As requested, attached are Ford comments, Alliance Comments and Ford comments to the TAR.

Docket ID No. EPA-HQ-OAR-0827

Alliance of Automobile Manufacturers Comments on Draft Technical Assessment Report: Midterm Evaluation of Light-Duty Greenhouse Gas Emission Standards and Corporate Average Fuel Economy Standards for Model Years 2022-2025 (EPA-420-D-16-900, July 2016)

Figure A-1: Comparison of NHTSA Base Engine Map to similar OEM 2.0L Benchmark Engine

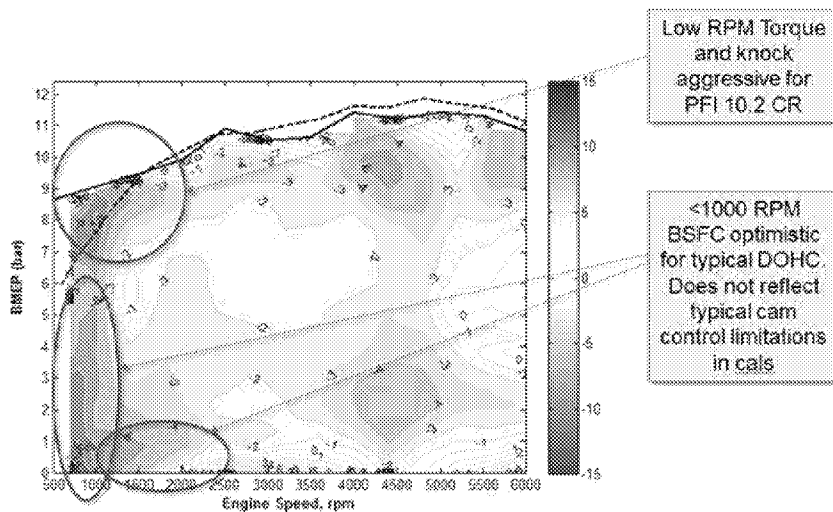
Figures A-1 and A-2 below capture the BSFC delta comparison with the key findings. Figure A-1 is a comparison to an original equipment manufacturer (OEM) benchmark 2.0L, four cylinder (cyl), naturally aspirated (NA), PFI, DOHC, dual cam variable valve timing (VVT), 10.2 CR engine. Figure A-2 is a comparison to a Honda Accord 2.4L, 4cyl, NA, gasoline direct injected (GDI), DOHC, VVT, 2-step VVL, 11.1 CR engine benchmarked by the United States Council for Automotive Research (USCAR). These comparisons illustrate the optimistic assumptions in the NHTSA Base Engine Map, as the efficiency of the NHTSA Base Engine Map is similar to a production engine with much more technology.

Figure A-3: Comparison of IAV Gasoline Engine2 Map to NHTSA Base Engine Map

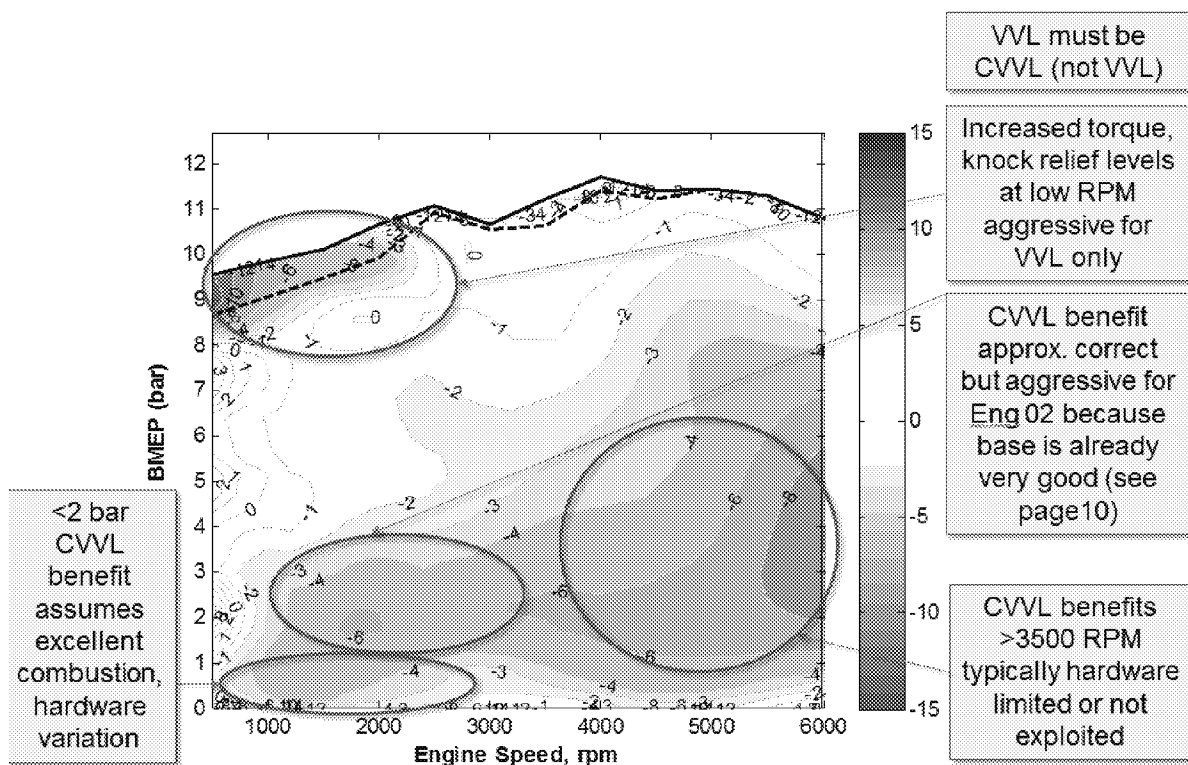
Figure A-3 compares the BSFC of the NHTSA Base Engine Map to the IAV Gasoline Engine2 Map with the key findings highlighted.

Figure A-4: Comparison of IAV Engine3 Map to IAV Engine2 Map

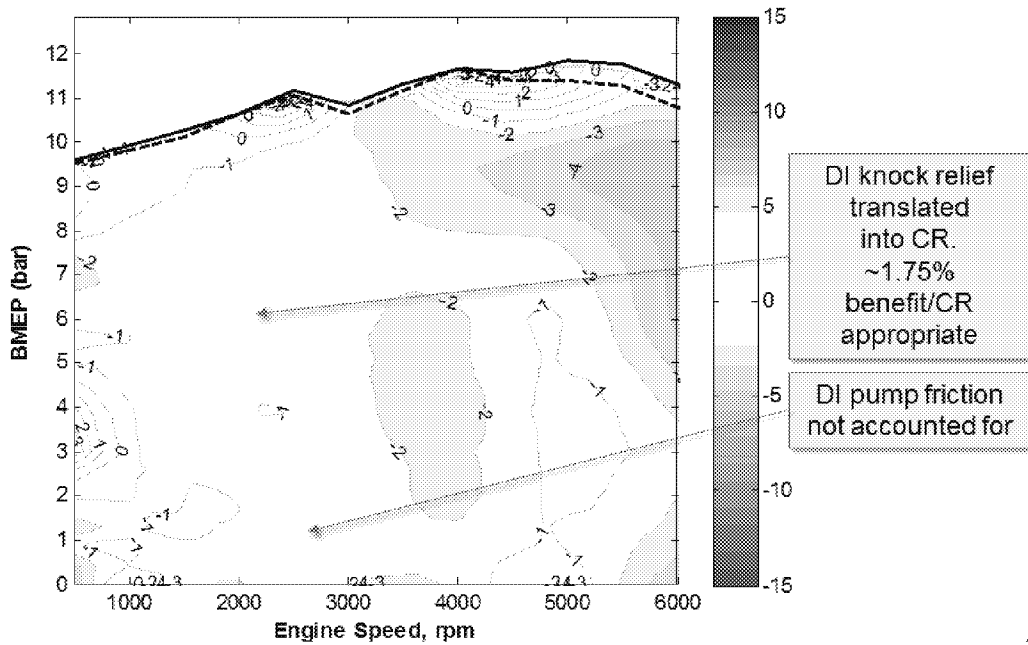
- The GDI pump friction isn't properly taken into account (Figure 1-4).
- Optimistic knock relief assumptions are used (Figure 1-4).
- Aggressive CVVL assumptions for low load operation were made across the speed band (Figure 1-5).
- The pumping work reduction is overstated, especially considering that the benchmark Honda engine used for comparison here is already a 2-Step VVL engine (Figure 1-5).

Figures A-4 and a-5 below capture the BSFC comparison with the key findings. Figure A-4 is a comparison to IAV Engine2 Map to isolate estimated GDI benefits. Figure A-5 is a comparison to the USCAR benchmarked Honda 2.4L engine with similar technologies.

Figure A-6: Comparison of IAV Engine4 Map to IAV Engine3 Map

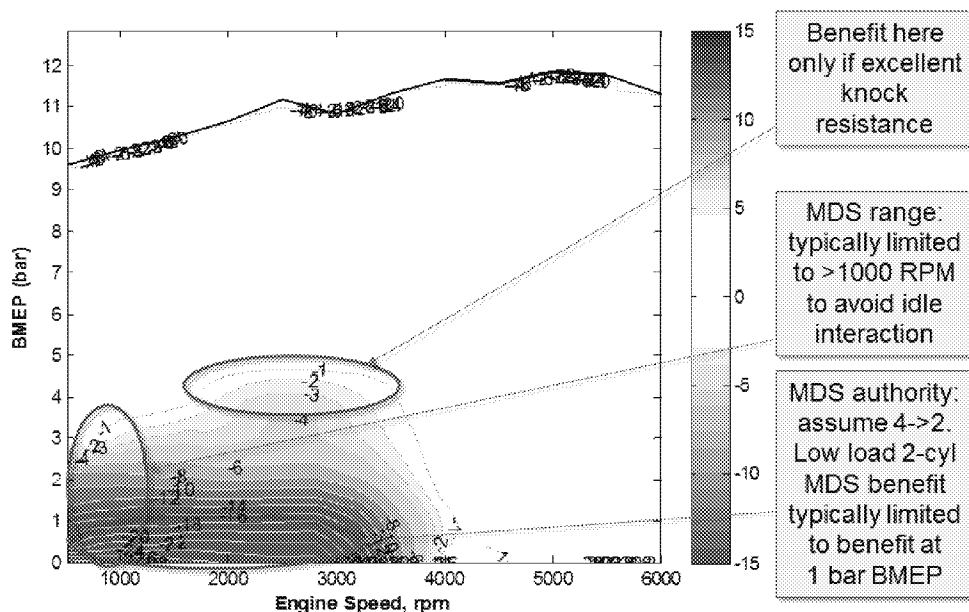
Figure A-6 below captures the BSFC comparison with the key findings.

Figure A-13: Comparison between IAV Gasoline Engine12 Map and IAV Gasoline Engine13 Map; Displacement Change without Full Modeling Questionable

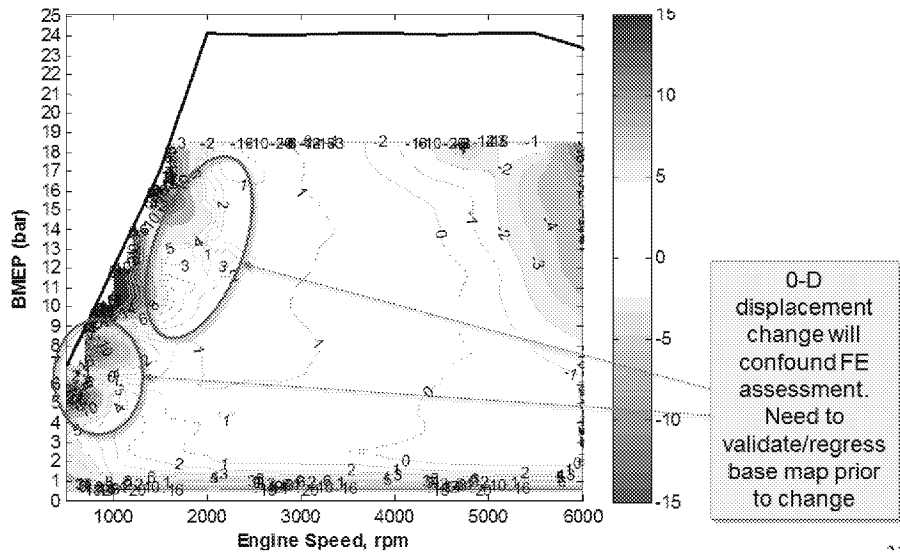
Figure A-13 captures the effect of a 0-D displacement change from 1.6L to 1.2L (downsizing effect).

Figure A-14: IAV Gasoline Engine14 Map - Aggressive Fuel Surface With Atypical Results

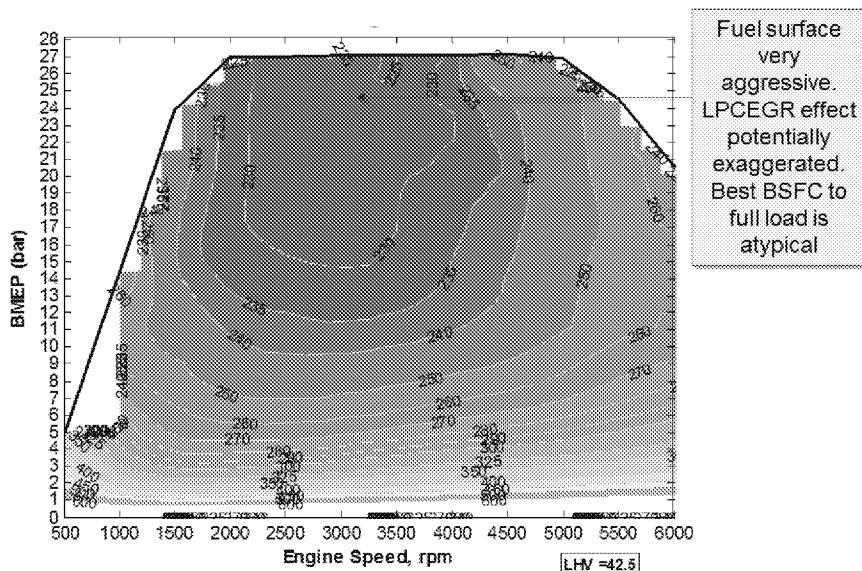
Figure A-14 below illustrates the effect of aggressive LPCEGR on the 1.0L 3-cylinder engine.

Figure A-15: Lumped Parameter Model compared to Test Data

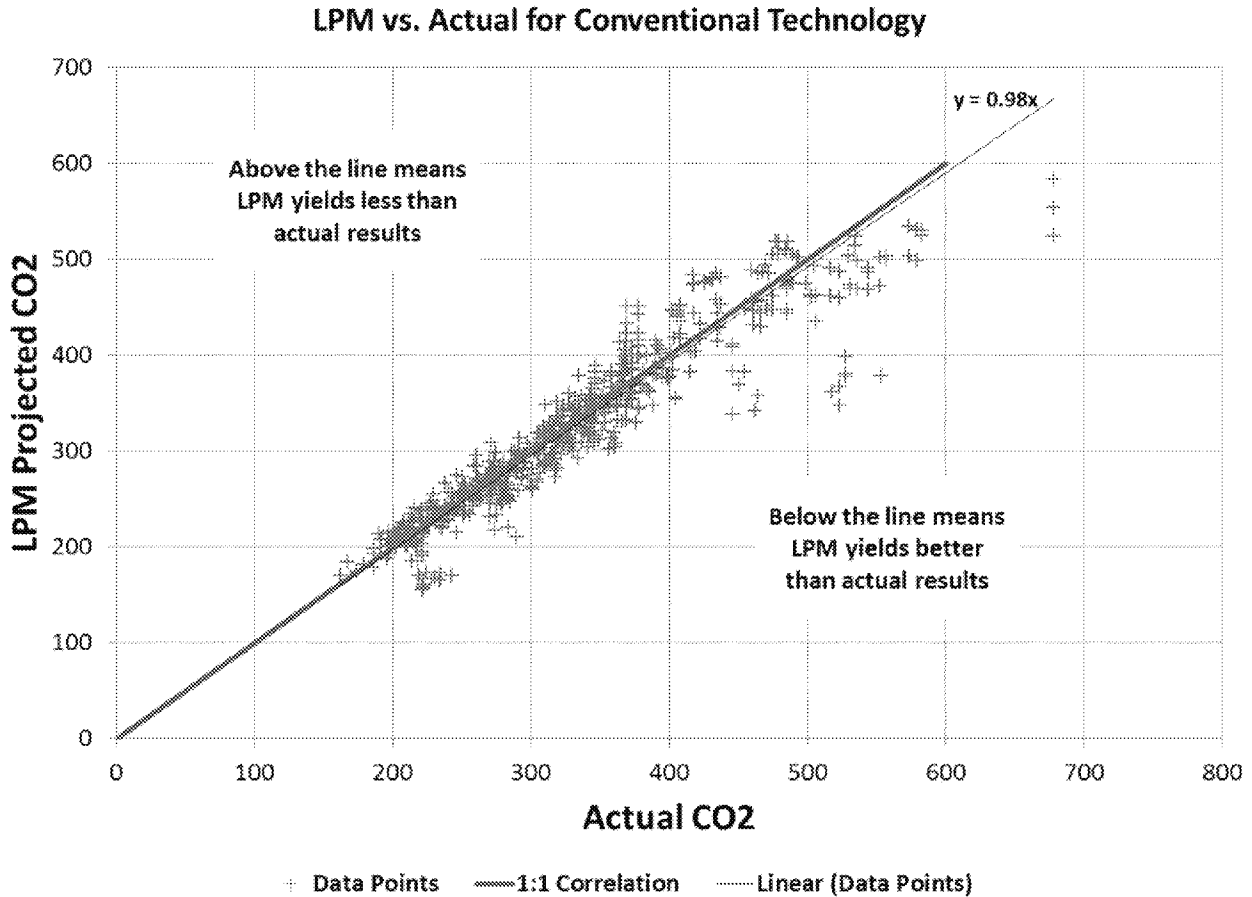
The results of this process, after sorting for conventional technologies (no hybrids, turbocharged engines, or eight-speed transmissions), are plotted below in Figure A-15. In this and the following figures, results below the line show data where the LPM predicted lower CO₂ than the vehicle actually emitted. Conversely, points above the line show when the vehicle was better than the LPM estimate. The standard error for this data is 31 g/mi, but the overall slope calculated as a best-fit line is about 2% from actual.

Figure A-16: Lumped Parameter Model compared to Test Data of Vehicles with 8-Speed Transmissions

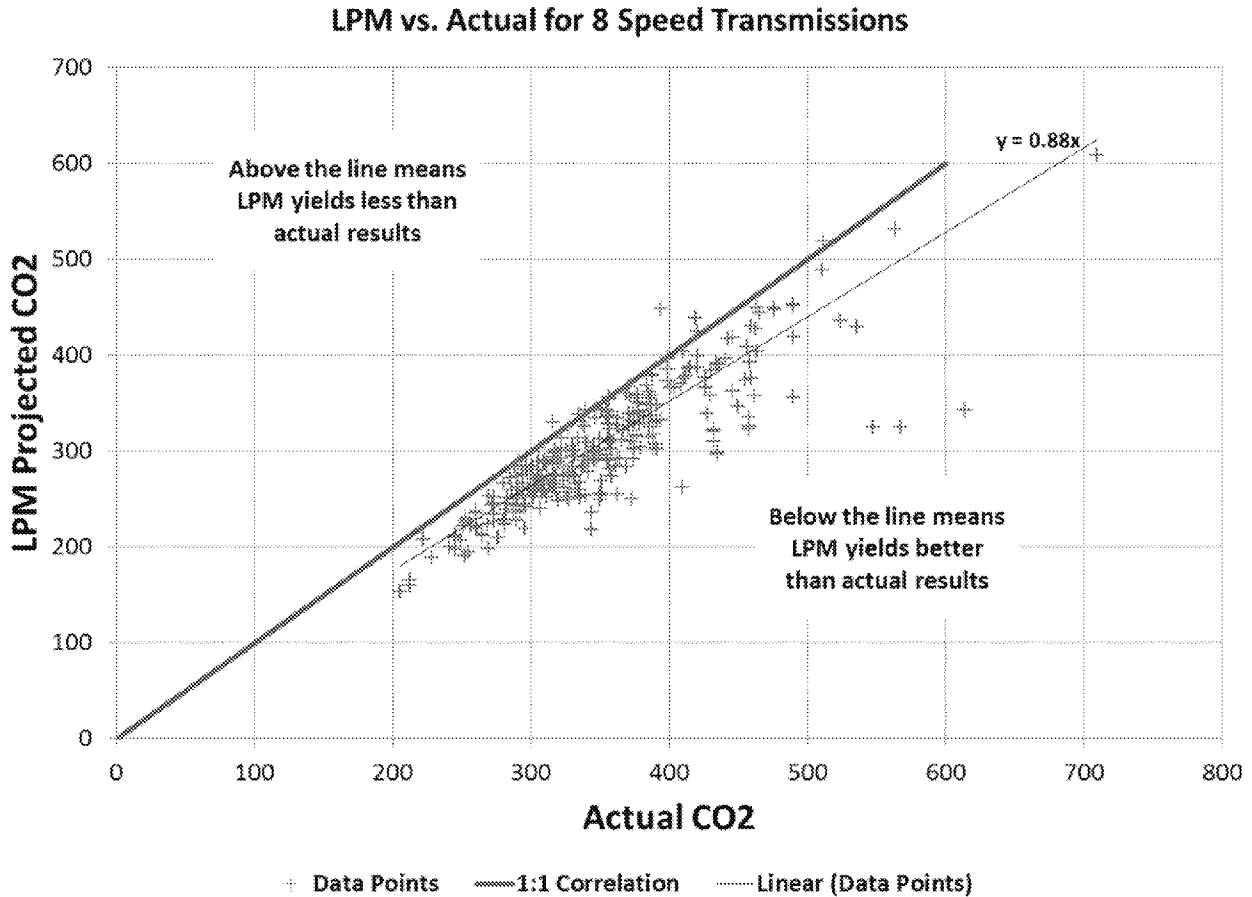
Figure A-16 shows the data after filtering for only eight-speed transmissions. Here the standard error has increased to 49 g/mi, but of greater concern is the change in slope of the best-fit line. The overall trend shows that the LPM is more optimistic by 12% than what manufacturers have, on average, been able to deliver. This is the powertrain technology, aside from variable valve timing, with the highest projected penetration (~90%) from the OMEGA model.⁷⁵

Figure B-1: Comparison of Mazda SkyActiv 2.0 L - EPA Data (96+ RON) vs. USCAR Data (91 RON)

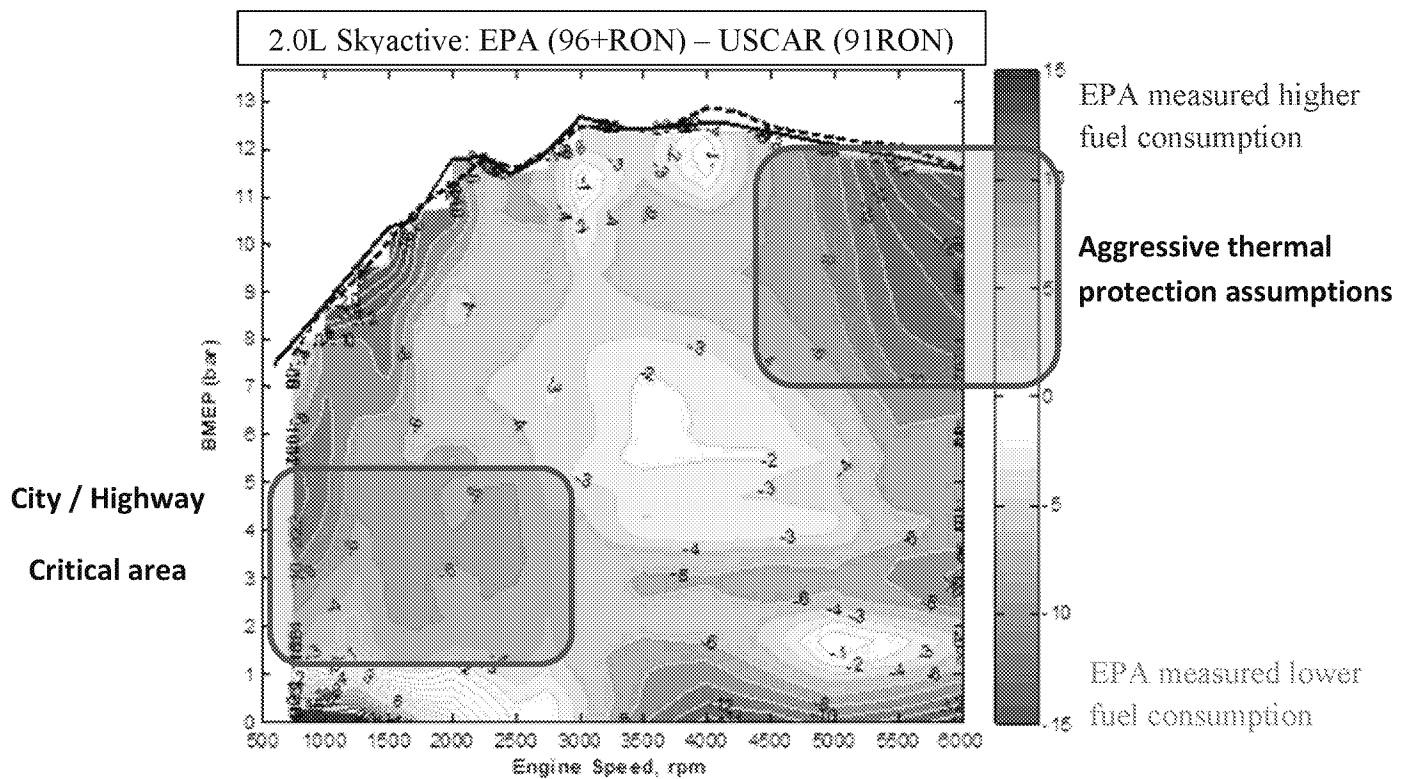
The differences between the USCAR and EPA fuel maps described in the paragraph above are shown in Figure B-1 below. The green areas in the plot (where EPA projects lower fuel consumption than USCAR) are due to knock limit improvements associated with EPA's use of premium fuel for benchmarking. The octane advantage can clearly be seen in the comparison, and results in engine fuel map benefits that cannot be achieved with market grade regular and Tier 3 certification test fuels.

Figure B-2: ATK2 Torque Curve Discrepancy between SAE and ALPHA^{98,99}

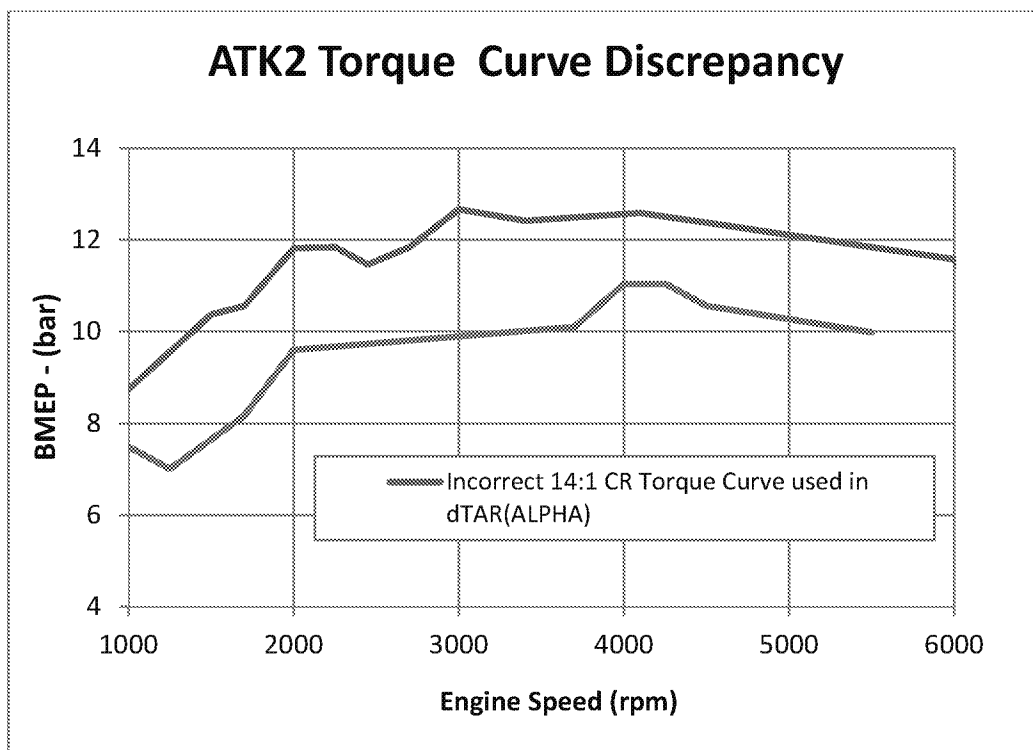
Additionally, it appears that there was a serious clerical error in translating the GT-POWER full load torque data to ALPHA which was then carried into the LPM's calibration. We note that in the SAE paper 2016-01-0565⁹⁶ the GT-POWER model correctly limited the full load torque of the engine due to knock onset. However, it is not clear that this significant reduction in torque was translated to the Advanced Atkinson Tech Package used in ALPHA simulation work which was subsequently used to calibrate the LPM model. This error incorrectly leads to exercising downsizing options because the performance metrics could theoretically be met with the torque that should have been limited as shown in SAE paper 2016-01-0565.⁹⁷ The net result is a large overestimation of the benefit with the Advanced Atkinson Tech Package. The modeled performance would be further degraded if correct CEGR assumptions were used as discussed below. Figure B-2 compares the two torque curves, baseline Atkinson, and the Advanced Atkinson Tech Package.

Figure B-3: MY 2025 Advanced Atkinson Tech Package Penetrations in the EPA Control Case Central Analysis with ICMs¹⁰²

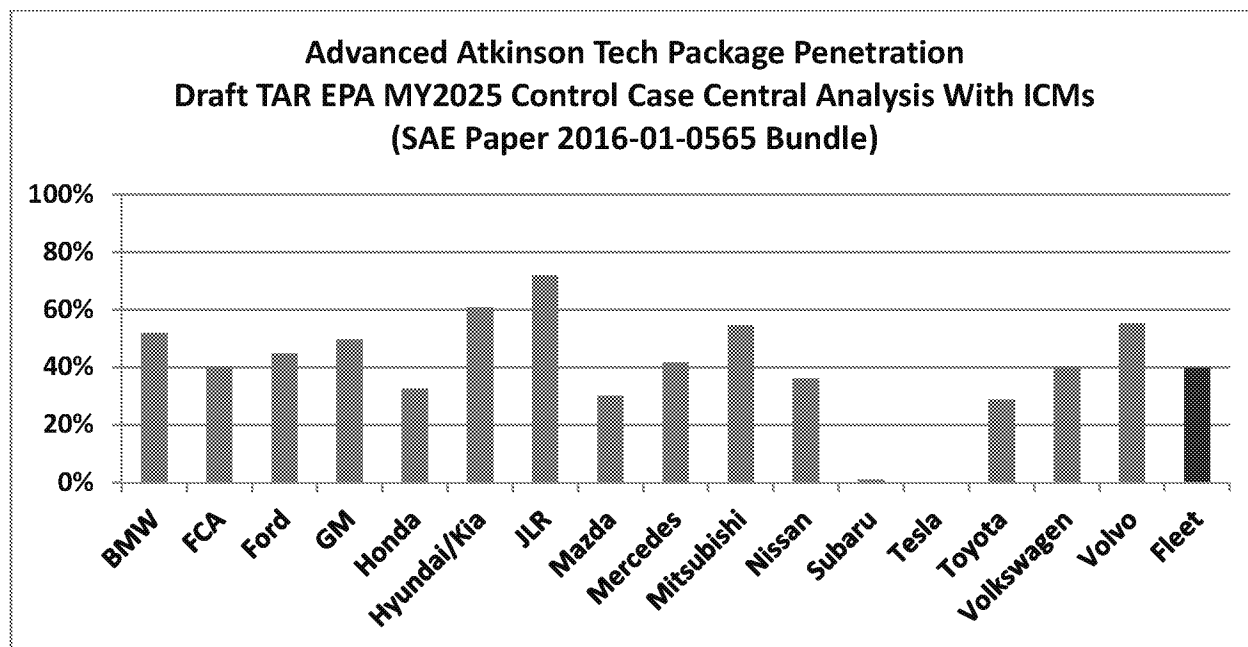
For the Draft TAR, EPA modeled that almost every automaker (except Tesla which only produces battery electric vehicles) will adopt the Advanced Atkinson Tech Package by MY2025 (Figure B-3), and that a number of manufacturers will exceed 50% penetration of this technology

Figure B-4: Speed-Load Points for a Ford F150 3.5L GTDI (EcoBoost) Engine¹⁰⁶

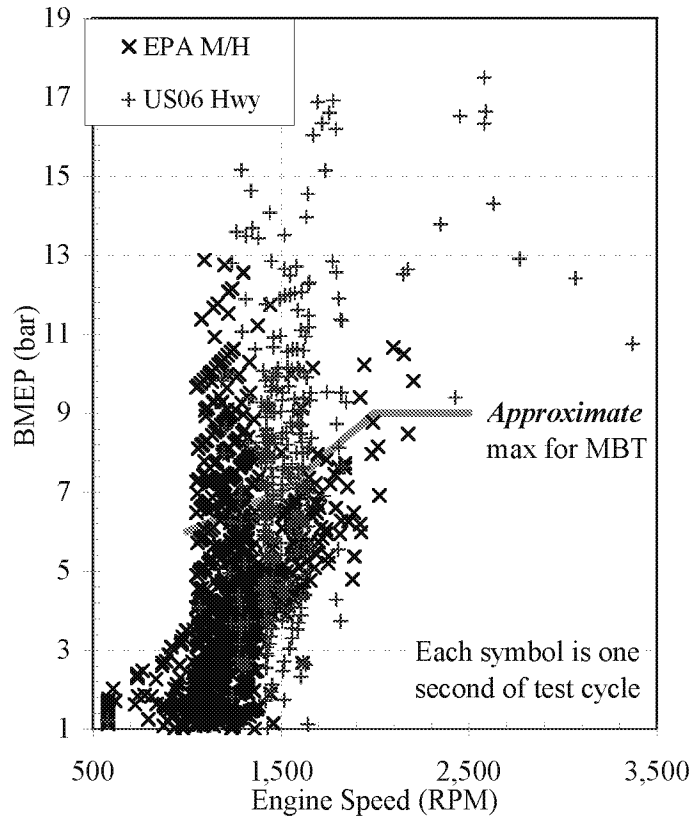
Figure B-4 demonstrates all the operating speed / load points over the city and highway test cycles from a Ford F150 3.5L GTDI (EcoBoost) engine. The limitations of regular grade (91 RON) fuel are illustrated by the points above the green mean best torque (MBT) line. To prevent engine damage for these operating points, the combustion phasing is delayed at the expense of combustion efficiency.
